re: Grading Plan Review
Proposed Apartment Building
3080 Navan Road – Ottawa, Ontario

file: PG6527-MEMO.01 Revision 1

Grading Plan Review

- Grading Plan – 3080 Navan Road (Rhythm Apartments), City of Ottawa – Project No. 122180 – Drawing No. 122180-GR Revision 3, dated November 21, 2023.

PG6527-MEMO.01 REVISION 1 - PROPOSED LIGHTWEIGHT FILL PLAN

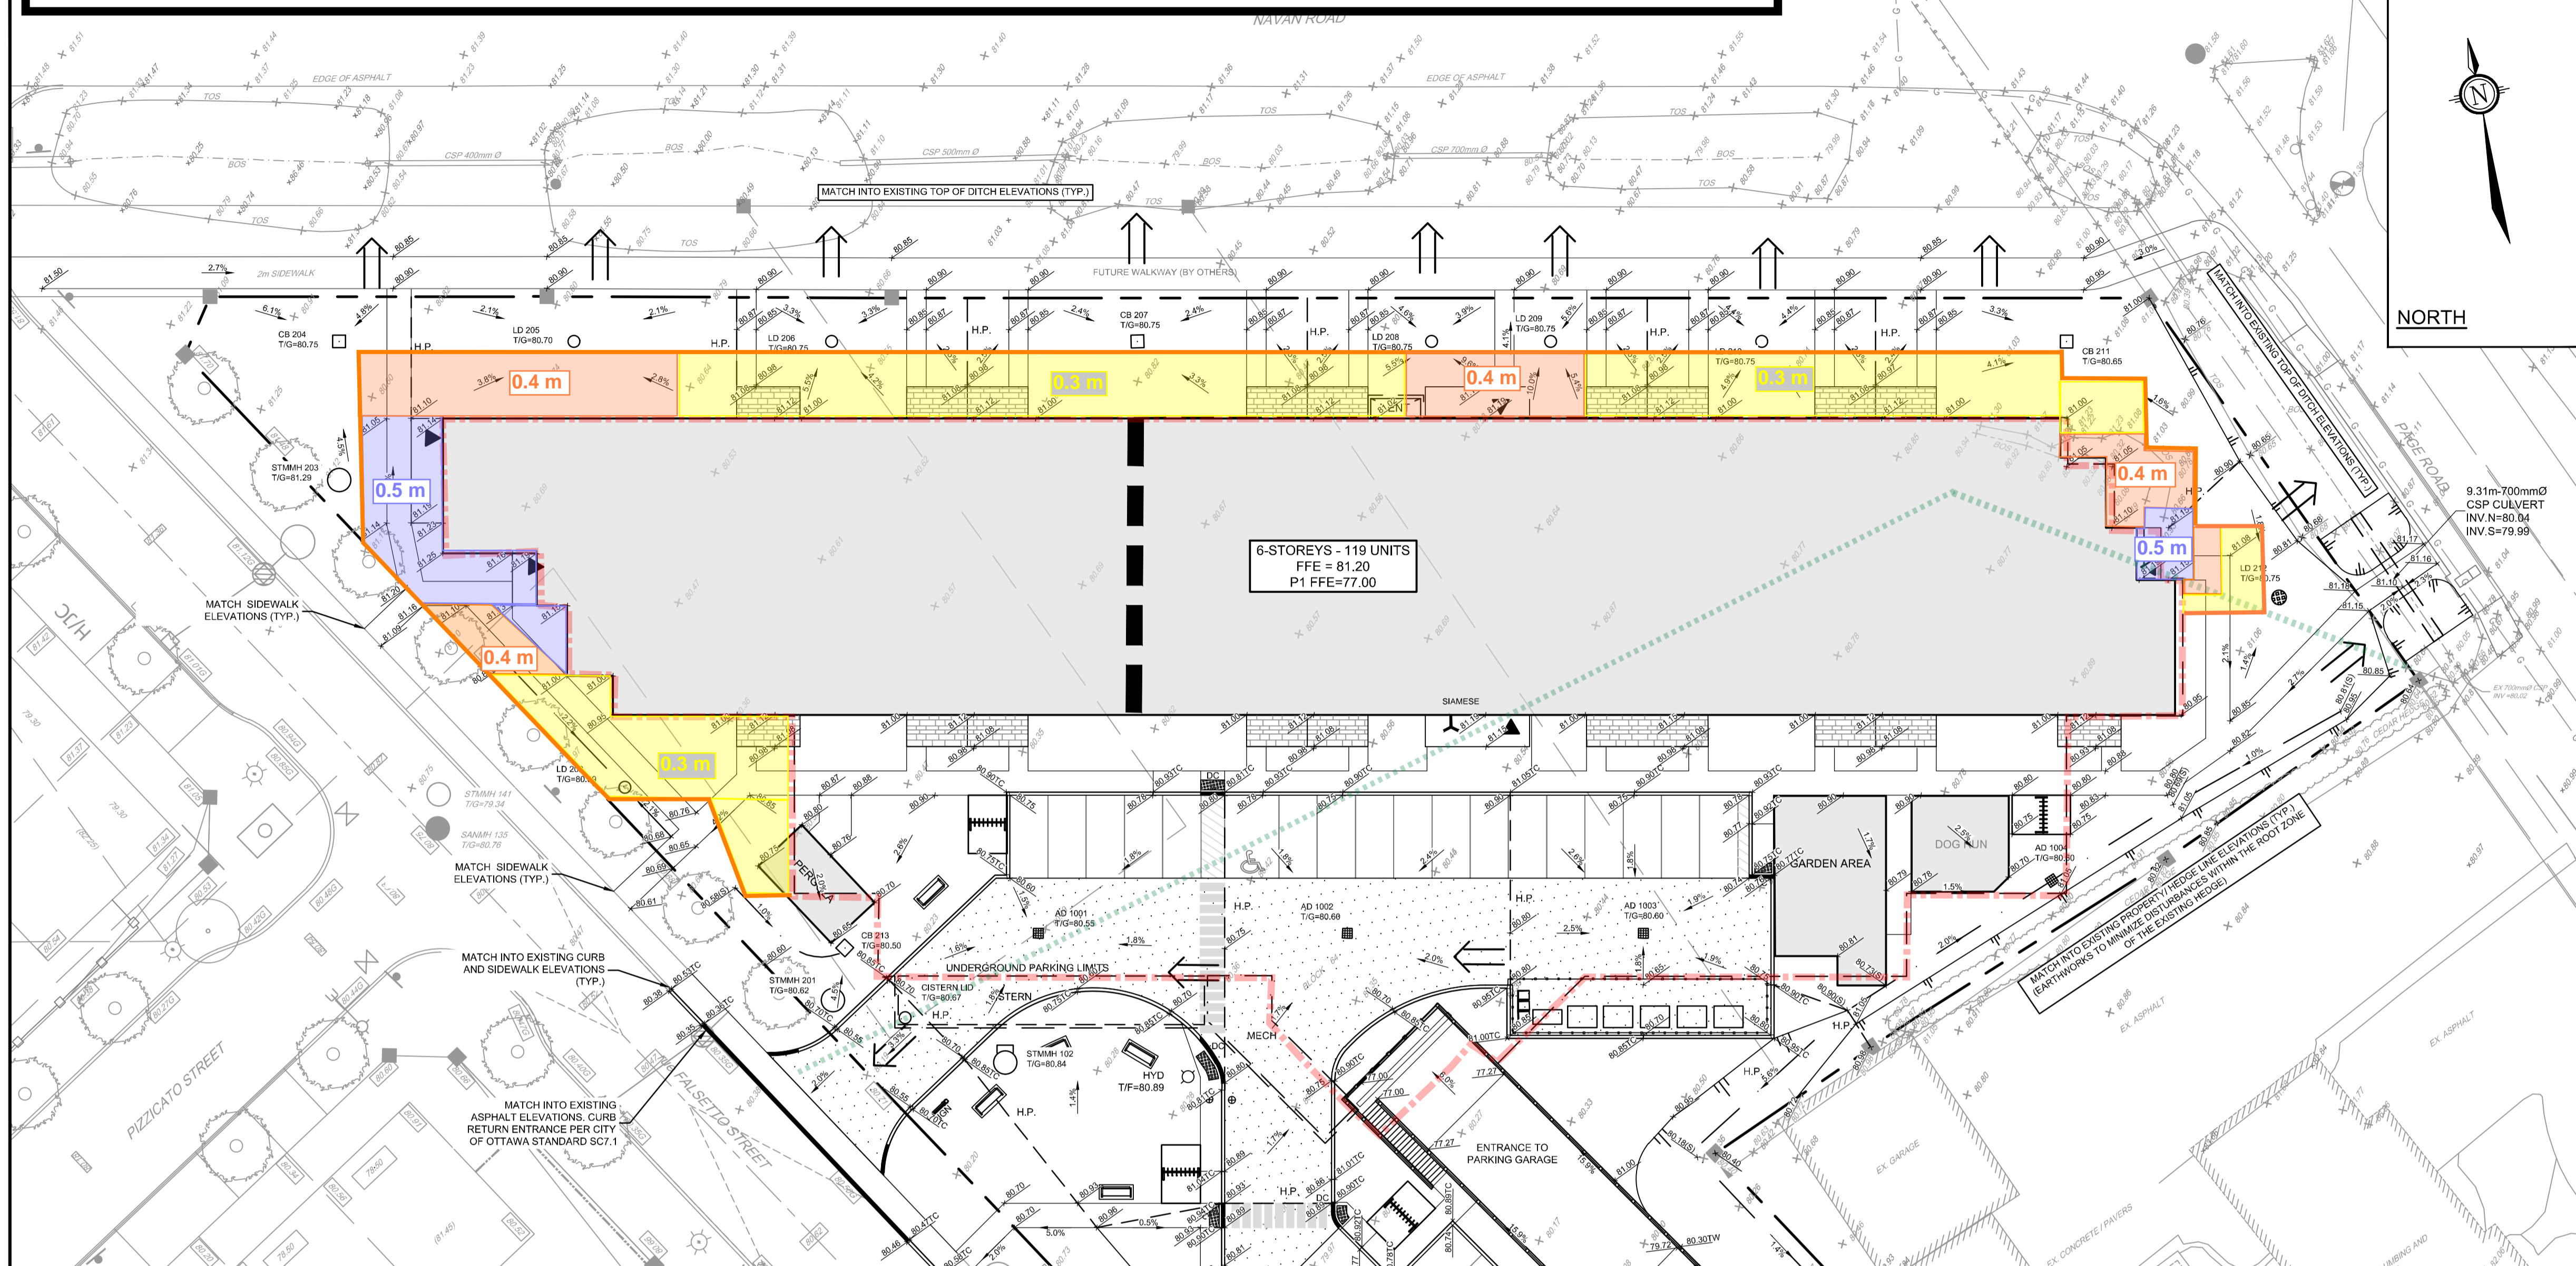
However, in the north corner of the site, grade raise exceedances of up to approximately 0.5 m are currently proposed for the landscaped and hardscaped areas located within 5m of the building footprint. Where these grade raise exceedances are proposed, lightweight fill (LWF) is recommended to mitigate excessive settlement. The attached figure PG6527-Figure 1 – Lightweight Fill Recommendations indicates the approximate LWF locations and thicknesses which are recommended.

Overall, the LWF should consist of EPS (expanded polystyrene) geofoam blocks, which allow for raising the grade without adding a significant load to the underlying soils. For this application, EPS Type 15 should be used and extended a minimum of 5 m beyond the building footprint in all directions where it is being recommended to be used.

It should also be noted that EPS is difficult to use under the groundwater level, as it is buoyant, and it must be protected against potential hydrocarbon spills. Based on this, the placement of lightweight fill should be planned to provide a minimum of 1.5 m of backfill upon its surface. The lightweight fill layer is recommended to be placed a minimum of 500 mm above any perimeter drainage sleeves/pipes provided to the main building structures foundation and the associated open-graded stone layers.

THIS PLAN SHOULD BE READ IN CONJUNCTION WITH PATERSON GROUP MEMORANDUM PG6527-MEMO.01 REVISION 1 DATED DECEMBER 12, 2023. ALL VALUES INDICATED HEREIN ARE PROVIDED AS THICKNESSES OF THE LIGHTWEIGHT FILL LAYER.

IT IS RECOMMENDED A MINIMUM 500 mm THICK LAYER OF SOIL BE PROVIDED OVERTOP THE LIGHTWEIGHT FILL IN AREAS OF LANDSCAPING TO PROMOTE GROWTH OF VEGETATION OVERTOP OF THE LIGHTWEIGHT FILL LAYER.

THE ENTIRE LIGHTWEIGHT FILL LAYER SHOULD BE COVERED WITH A LAYER OF POLYETHYLENE THAT IS TAPED AT ALL SEAMS AND OVERLAPS BELOW THE TOP OF THE LIGHTWEIGHT FILL SURFACE.

THE LIGHTWEIGHT FILL LAYER IS RECOMMENDED TO BE LOCATED A MINIMUM OF 500 mm HIGHER THAN ANY PERIMETER DRAINAGE SLEEVES/LINES AND THEIR ASSOCIATED OPEN-GRADED STONE LAYER.

THE LIGHTWEIGHT FILL SHOULD BE PLACED ON RELATIVELY SMOOTH AND FLAT GROUND. BASED ON THIS, THE SOIL FILL SURFACE SHOULD BE COMPACTED IN PLACE AND CONSIDERATION SHOULD BE GIVEN TO PLACING SAND/STONE DUST OVER THE SURFACE TO PROVIDE AN ADEQUATELY SMOOTH AND FLAT SURFACE FOR THE LIGHTWEIGHT FILL LAYER
